CITY PLAN COMMISSION STAFF REPORT

Project Name
1901 Locust Townhomes

Request
CD-CPC-2023-00096
Development Plan

19TH AND LOCUST TOWNHOMES DEVELOPMENT PLAN

1 LANDSCAPE PLAN
1" = 10'

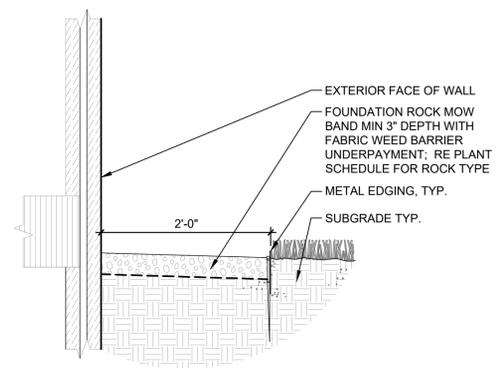
The developer has proposed landscaping in compliance with the Zoning and Development Code. There are four trees along 19th Street and Fescue Sod along the outside of both buildings. Locust Street was vacated in 1995 and is currently a private street. The landscaping along Locust street has been in place for a few years and will remain. The developer is providing an additional tree on the southeast corner in lieu of an additional tree on Locust Street.

7. The developer shall revise the landscaping plan to include additional native landscaping materials and confirm the proposed ground cover is compliant with Section 88-425-10-D of the Zoning and Development Code prior to ordinance request.

WEST BUILDING NORTH ELEVATION 1
1/8" = 1'-0"

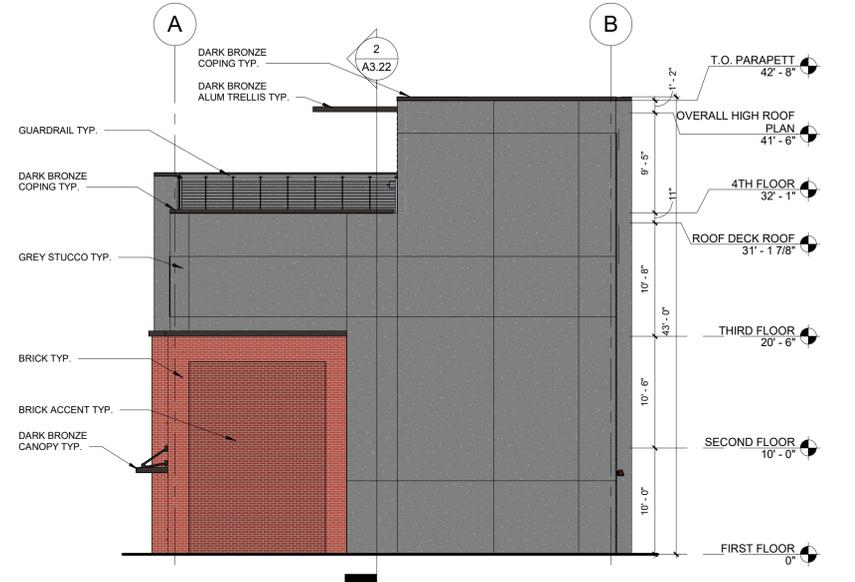
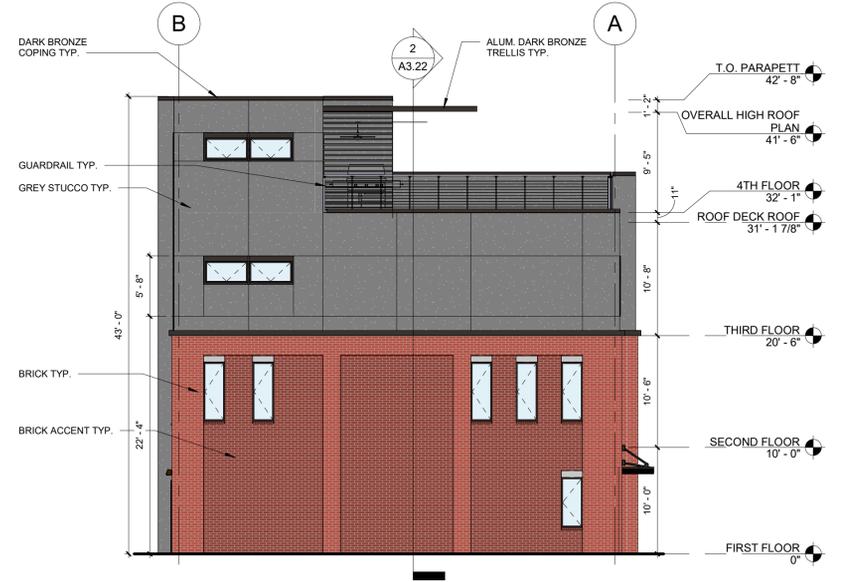
Brick is a high quality construction material, however the amount of stucco and the overall design of both structures needs improvement. The southern elevations of both buildings show a large amount of stucco directly facing an existing residential structure, more windows, architectural detailing, and architectural variation need to be provided. Nineteenth street is a prominent street in the Crossroads

area, so the architecture will need to more closely match the development to the West to create a more cohesive streetscape. The northern elevations of both structures also show a large amount of stucco facing 19th Street and the architectural design will need to include additional windows or a façade that mimics the entryway to a building. Additionally, the interior of the development needs to create a more welcoming environment for the residents. The interior facing walls of the development should more closely match the exterior facing walls with the added material changes, a reduction in the amount of stucco is also requested by staff.

5. Signage was not reviewed with this submittal, all signage shall conform to 88-445 and shall require a sign permit prior to installation.
6. The proposed development has too many blank walls throughout the project, the developer shall submit revised elevations showing an increase in architectural fenestration, variety in construction materials and/or proposed locations for murals on the northern, southern, and interior facades of both buildings to better match the surrounding area prior to ordinance request.
